ADDENDUM NO. 2

PAINT SHOP ALTERATIONS &  
 OUTDOOR PAINT BUILDING  
 GROVE USA, LLC  
 SHADY GROVE, PENNSYLVANIA

REVISION DATE  
**JULY 23, 2024**  
 ISSUE DATE  
**JULY 9, 2024**  
 DRAWING TITLE  
**PAINT BOOTH FOUNDATION PLAN**  
 PROJECT NO.

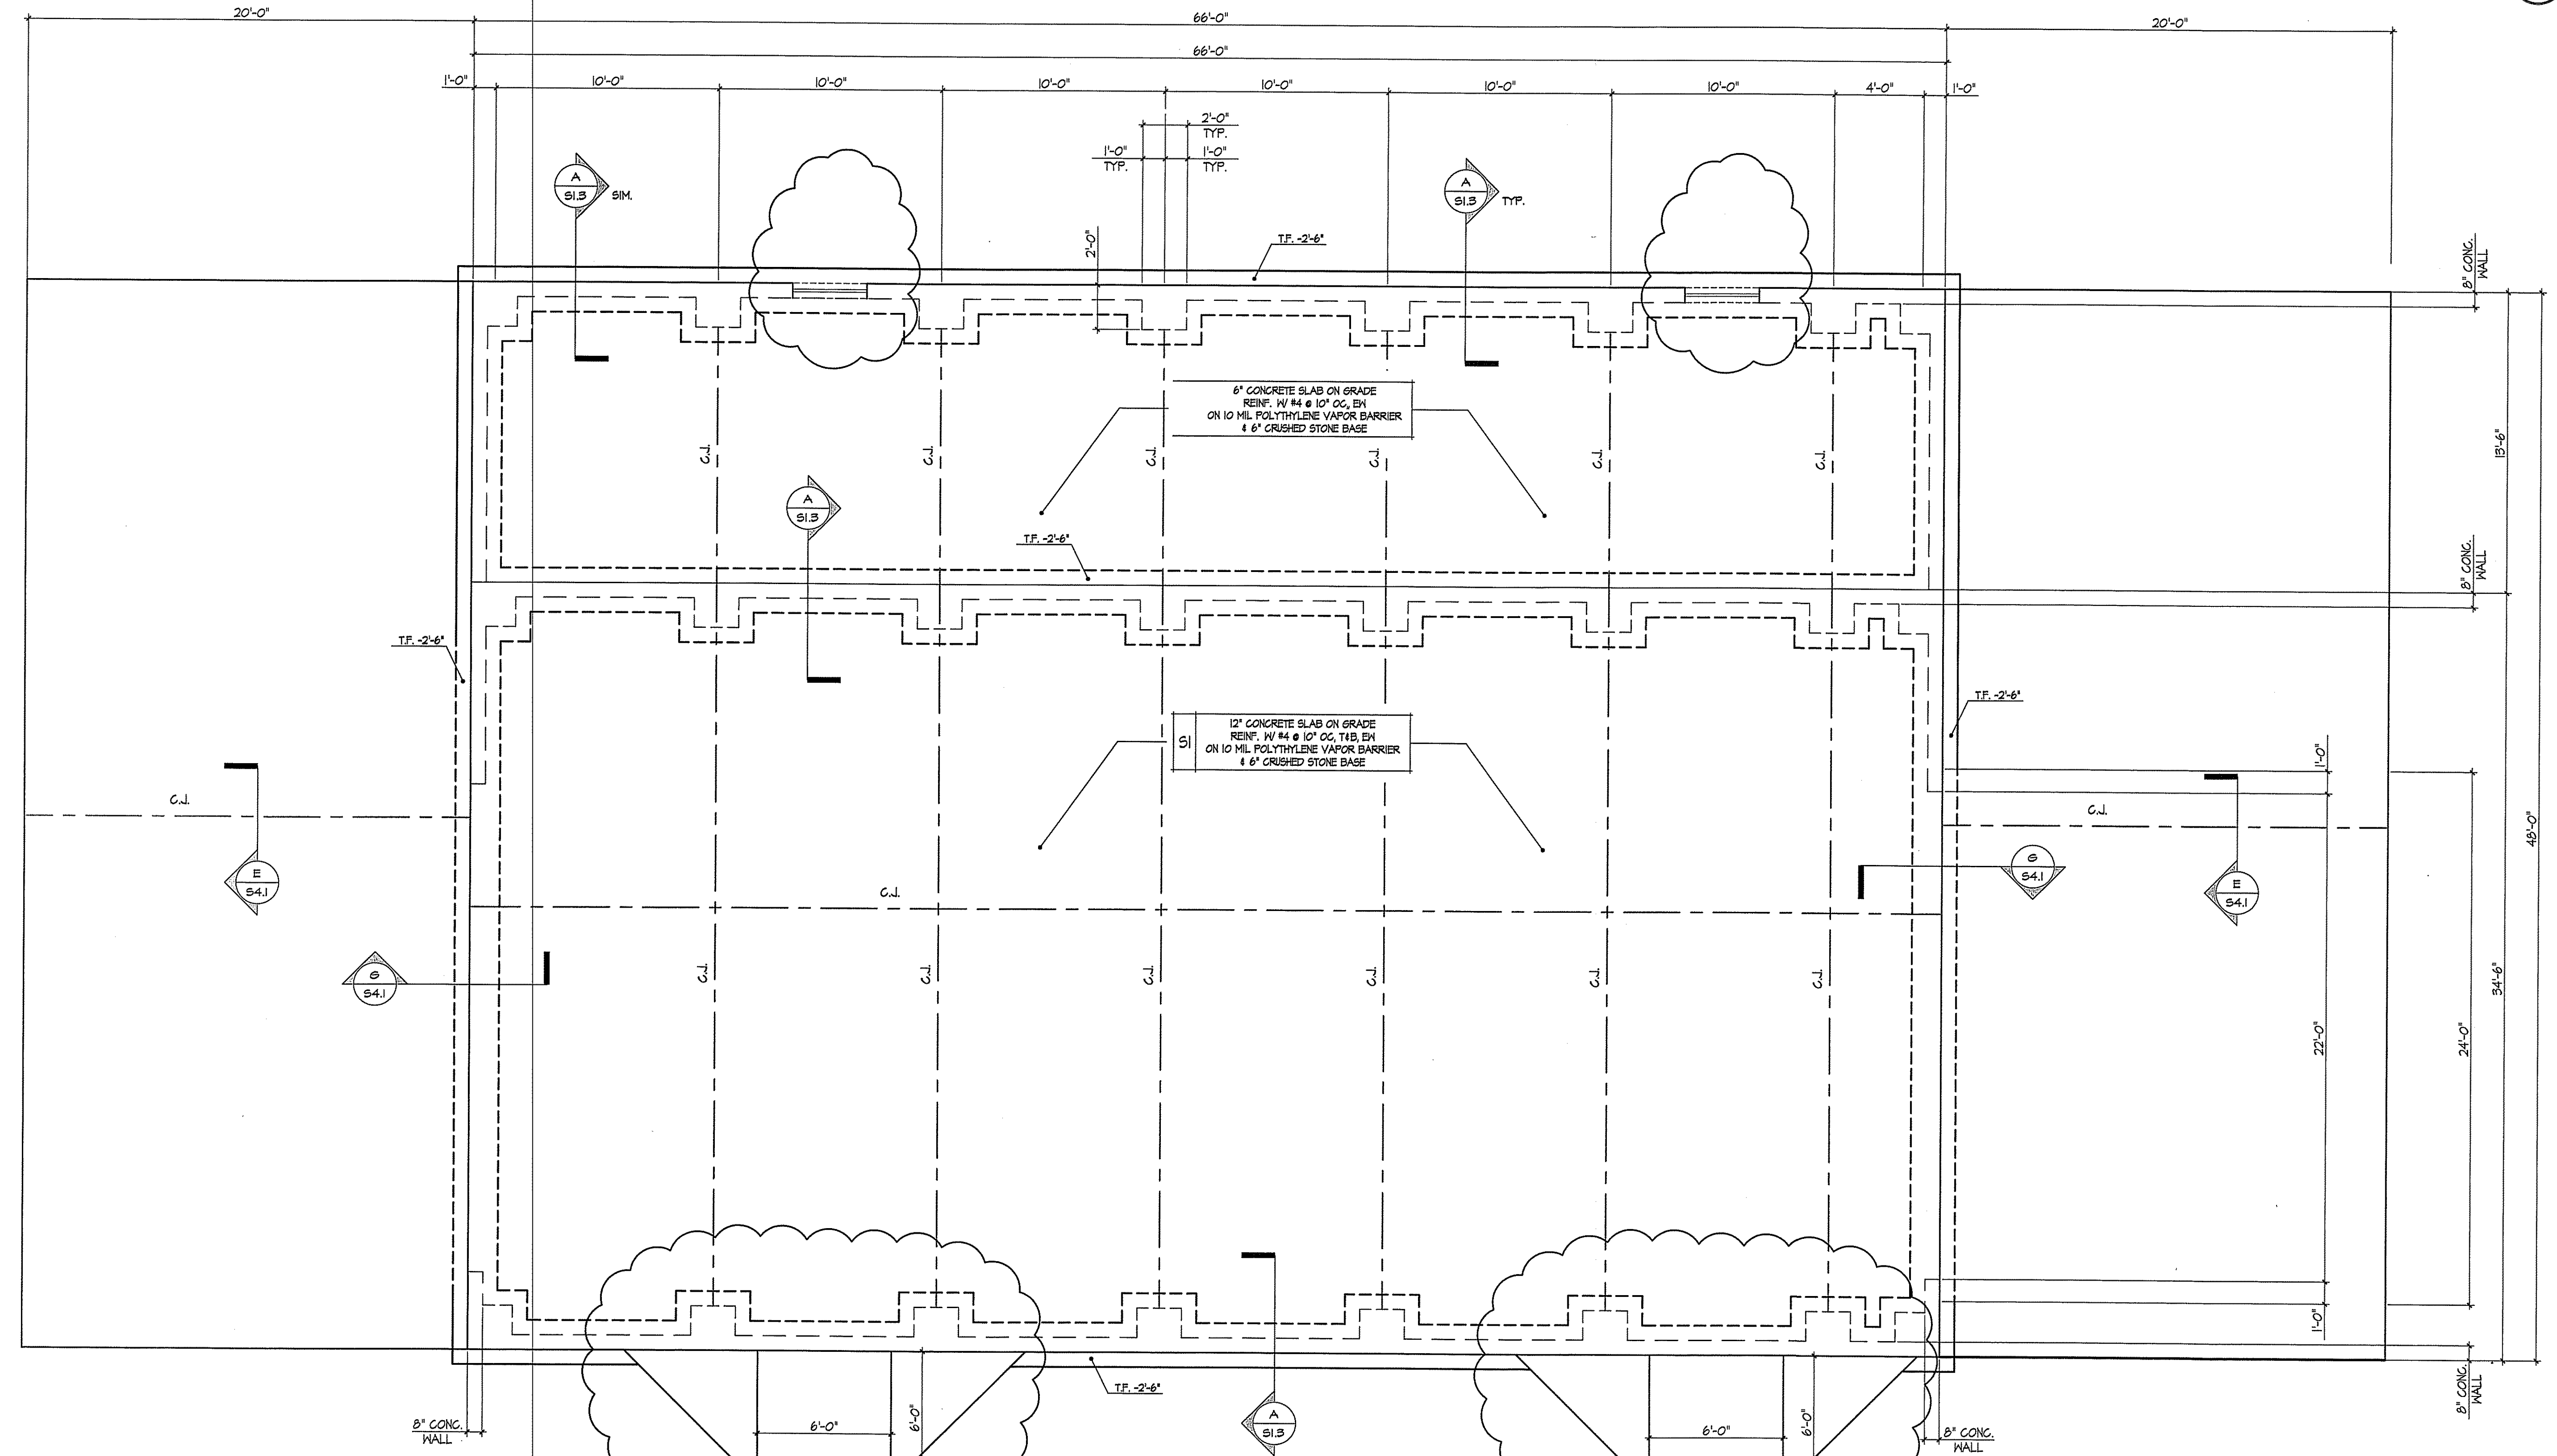
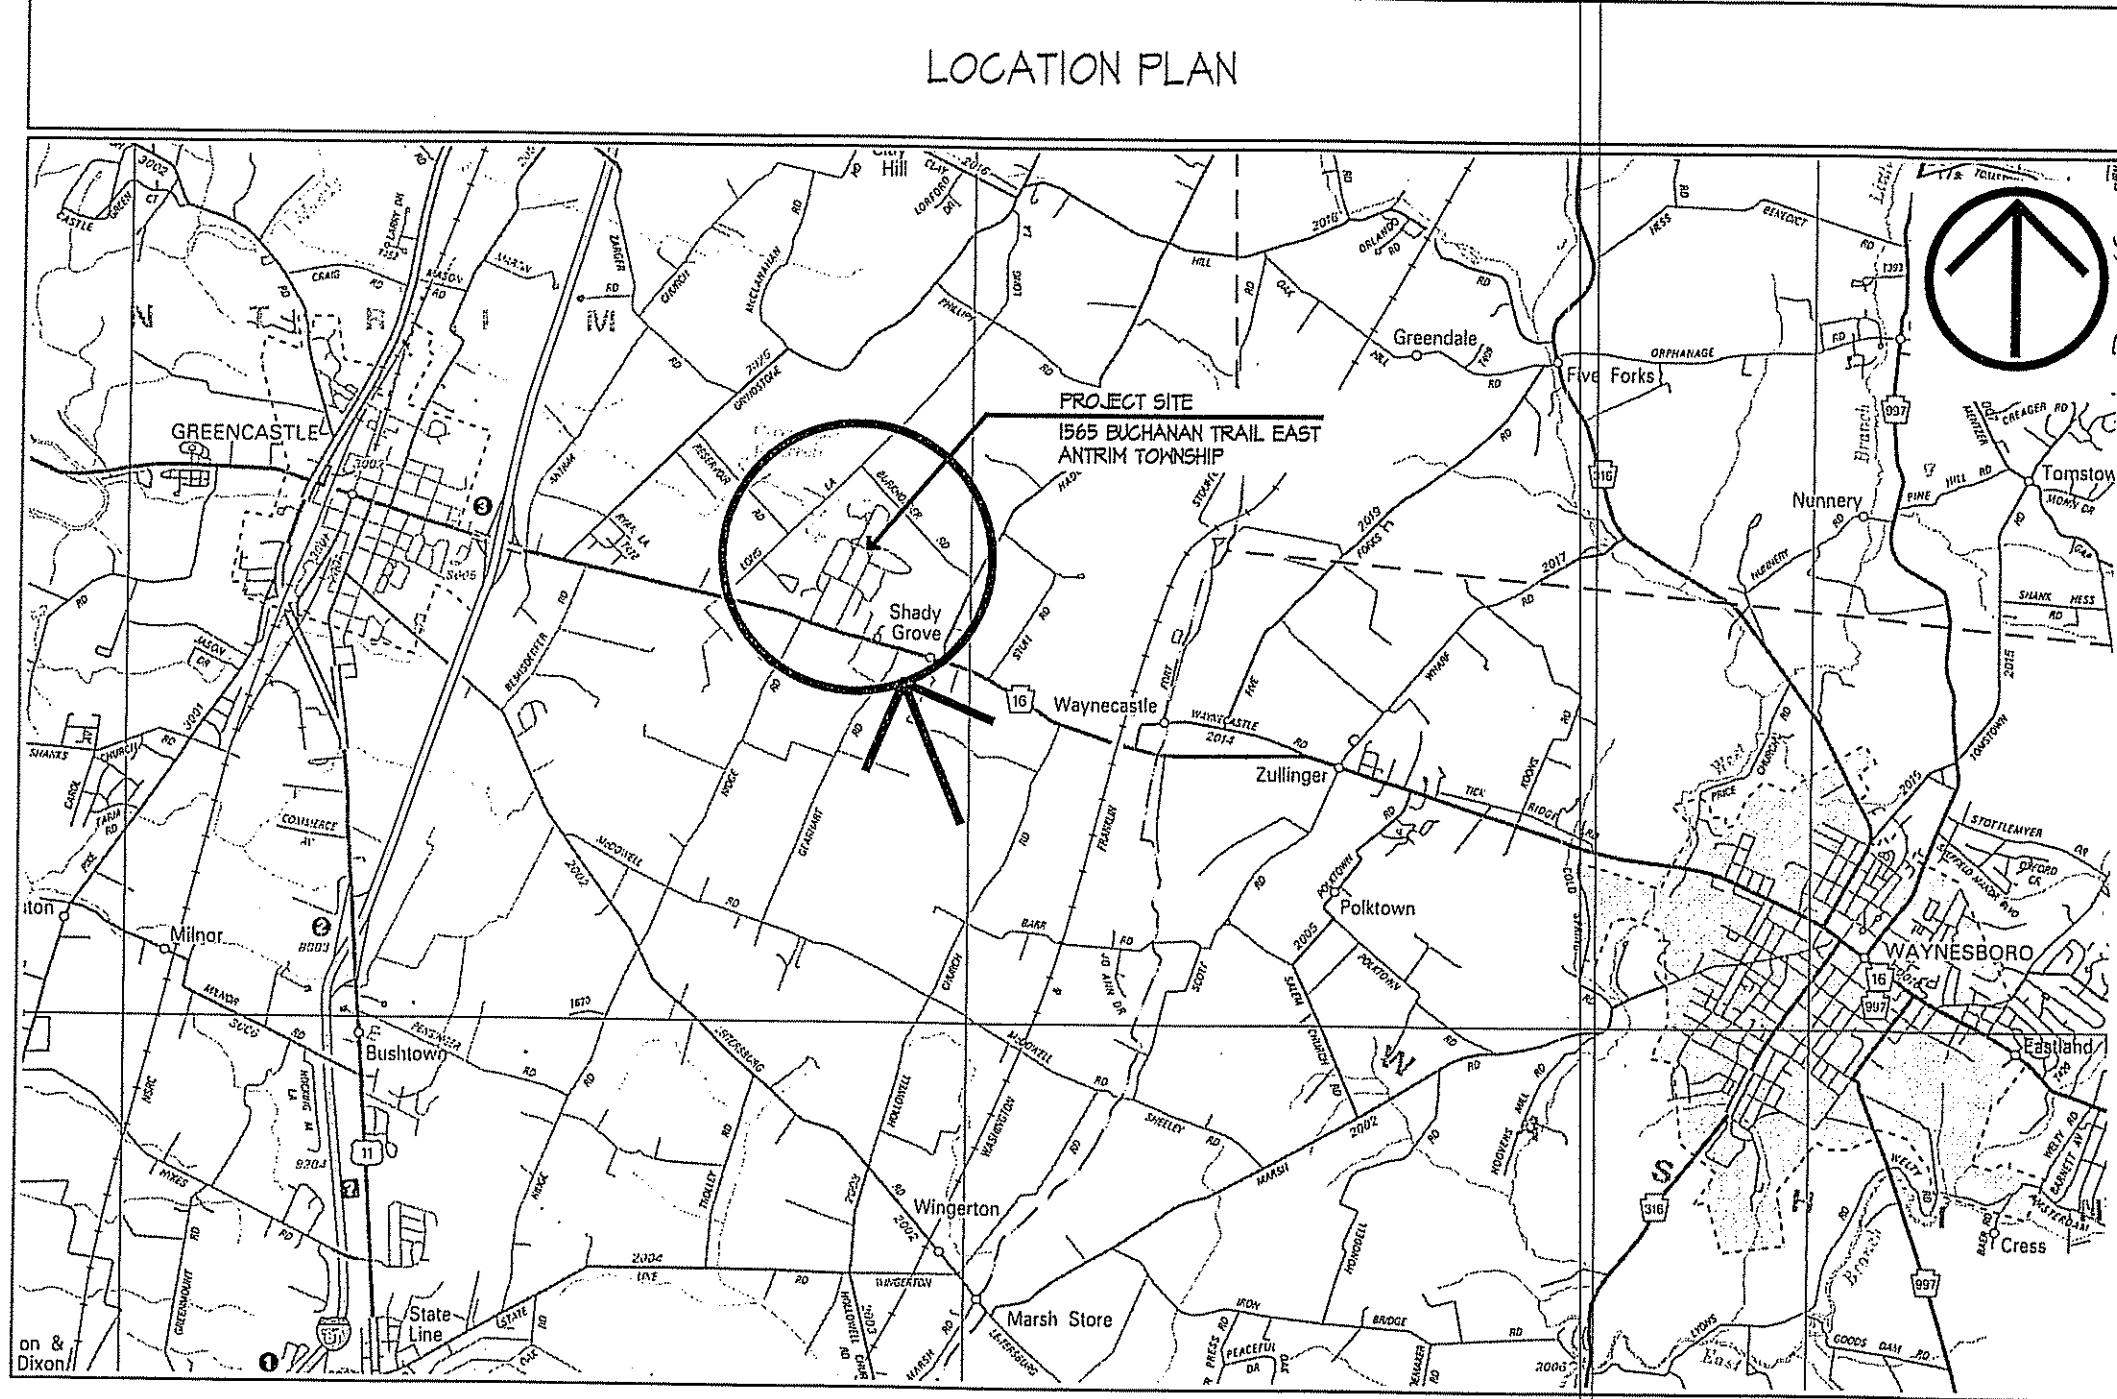
2. Drawing S1.3 is revised to reflect changes to eliminate the 6’ X 6’ equipment pads along the building and provide a 12” reinforced concrete pad as noted for supporting all exterior equipment and tanks associated with the Outdoor Paint Building.

REVISION DATE  
 JULY 23, 2024  
 ISSUE DATE  
 JULY 9, 2024  
 DRAWING TITLE  
 LOCATION & SITE PLANS +  
 CODE COMPLIANCE DATA  
 PROJECT NO.

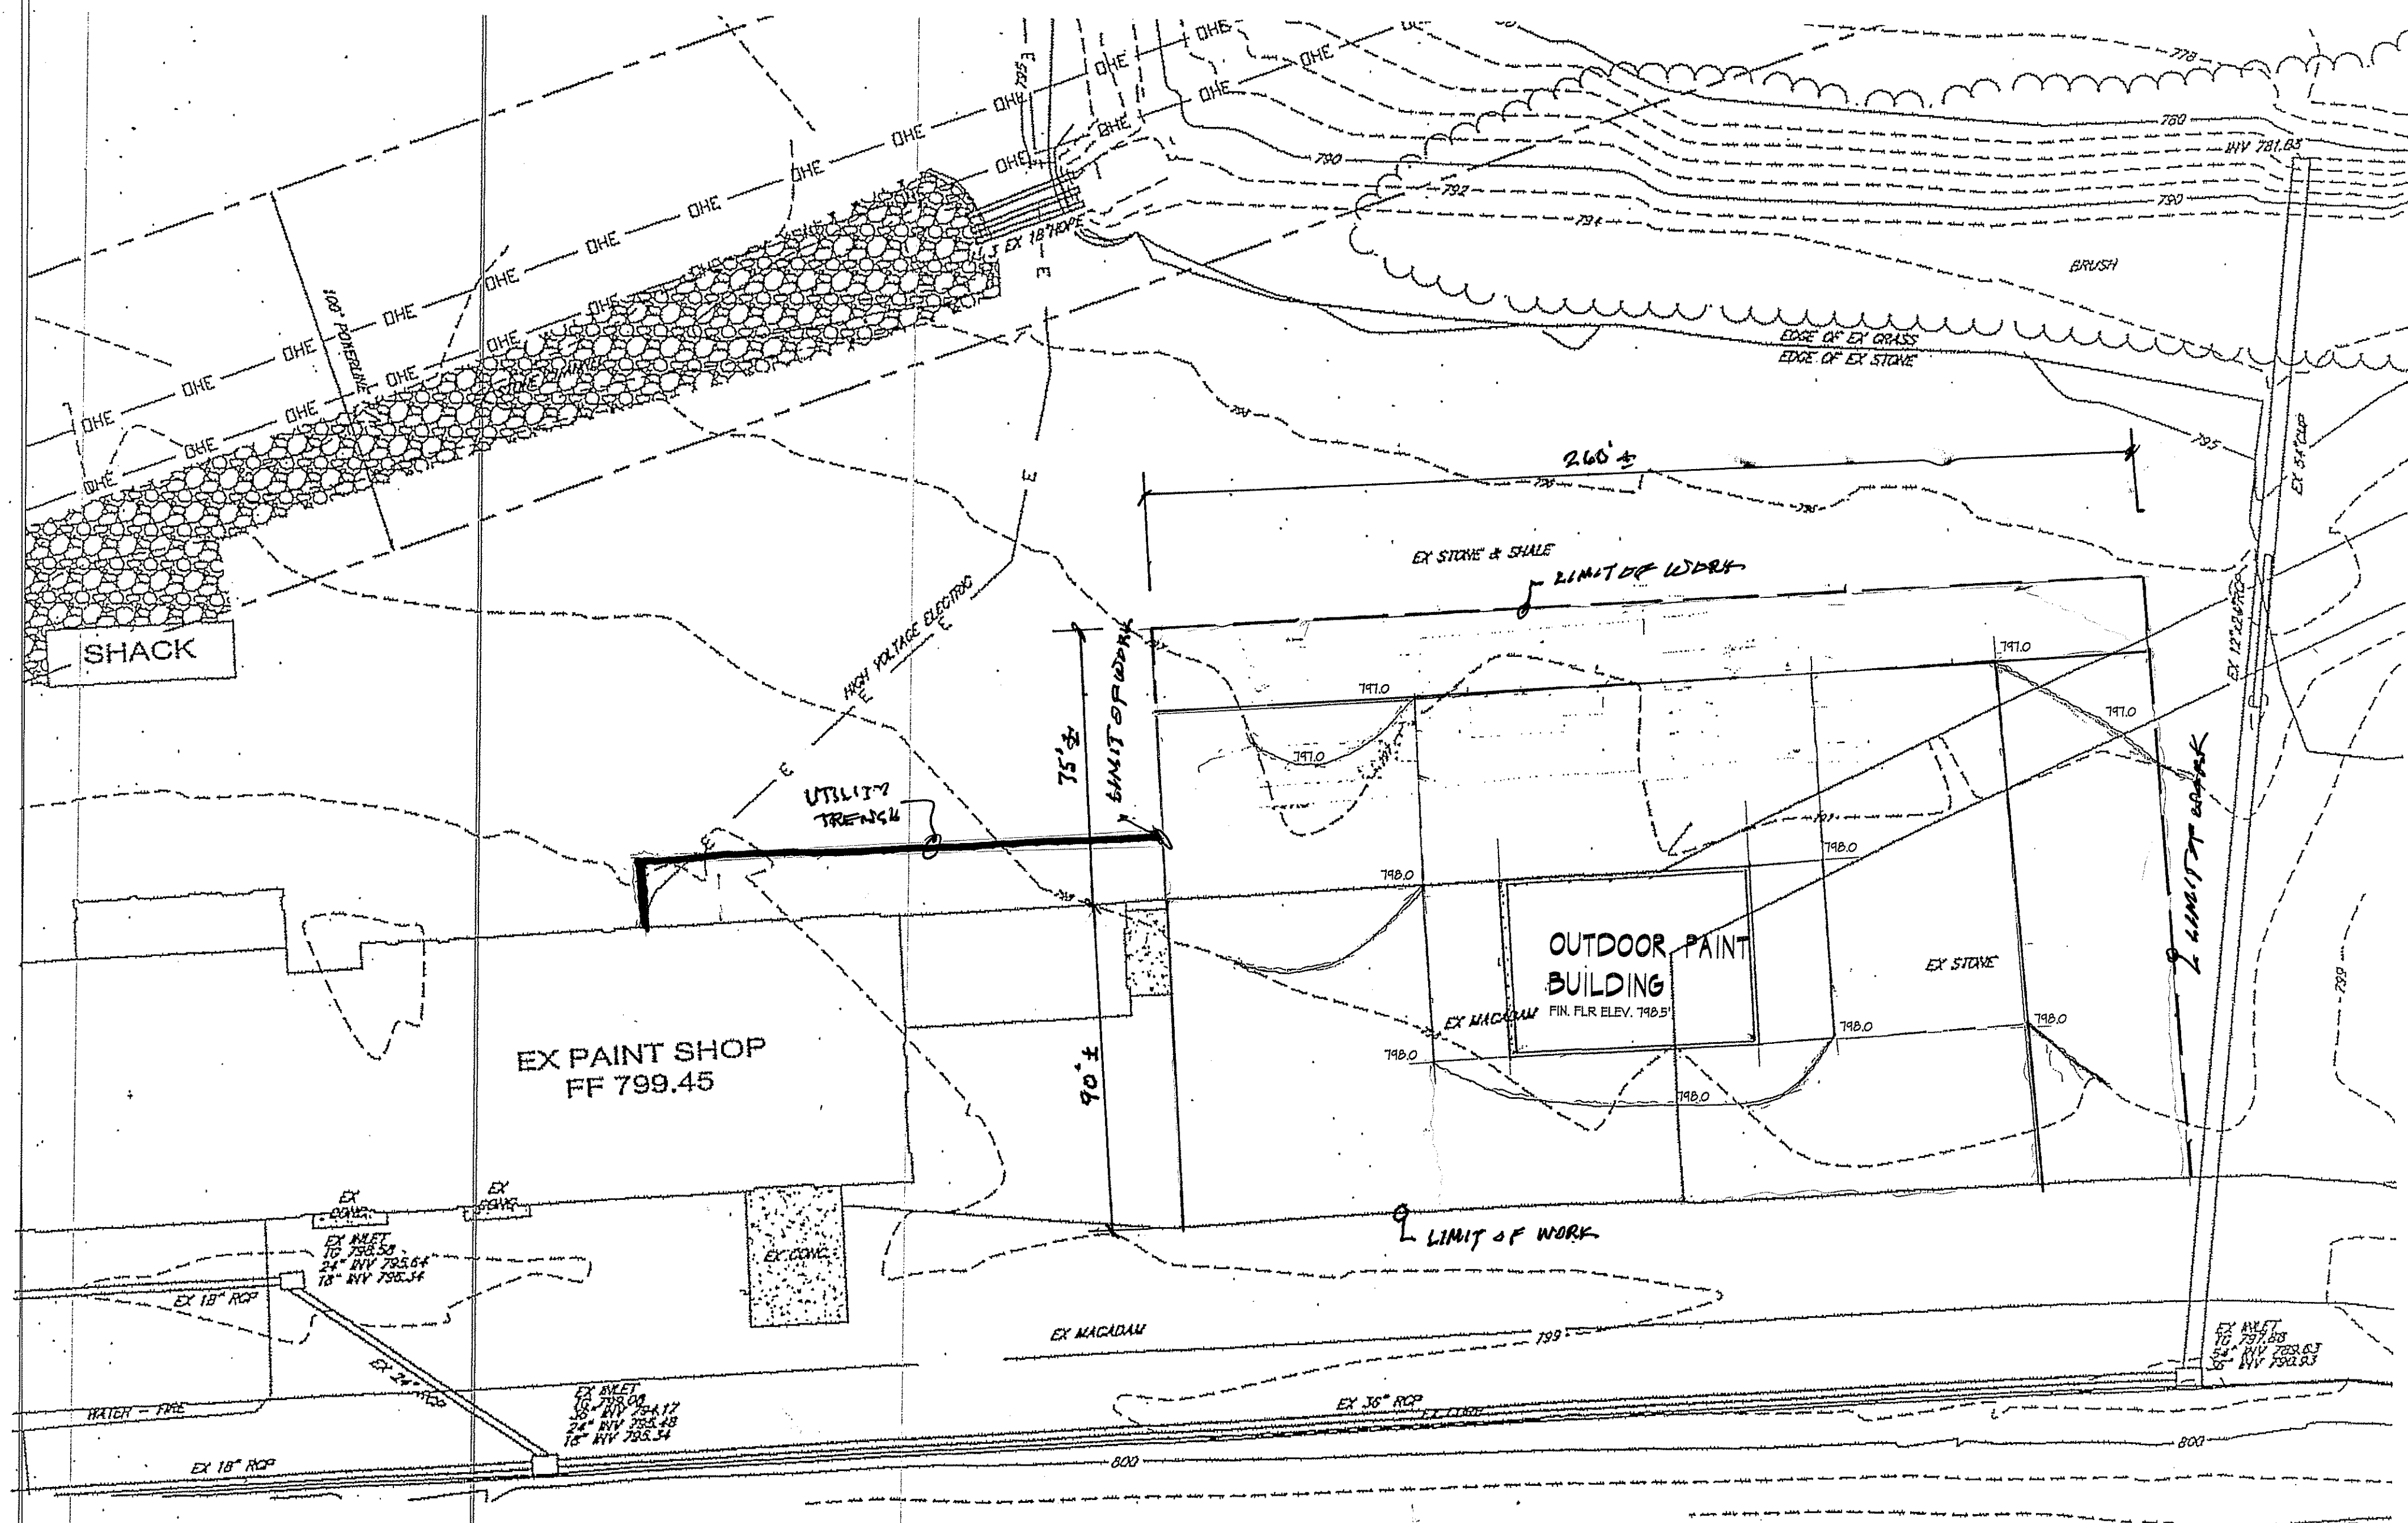
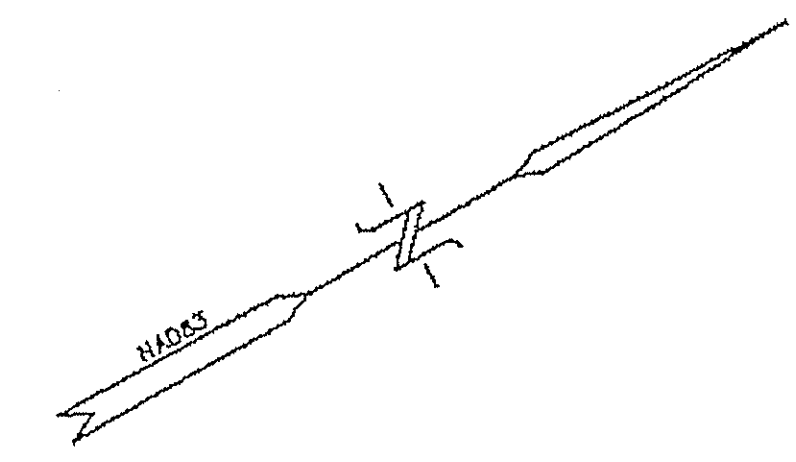
1. Drawing X1.1 and X1.2 are revised to reflect changes to show the limit of work associated with the project and site. The disturbed areas are to be restored with the designated 12” thick reinforced concrete pad. The two Alternate A-1 and A-2 for concrete pads have been revised and a revised Bid Form is attached.

5. In restoring existing grade and trenching that is not designated to be finished with the 12” reinforced concrete slab, the area shall be paved over compacted subgrade with 6” 2A stone subbase, 4” bituminous base course, 2 1/2” bituminous ID-2 binder course and 2” ID-2 wearing course per PennDOT specifications.
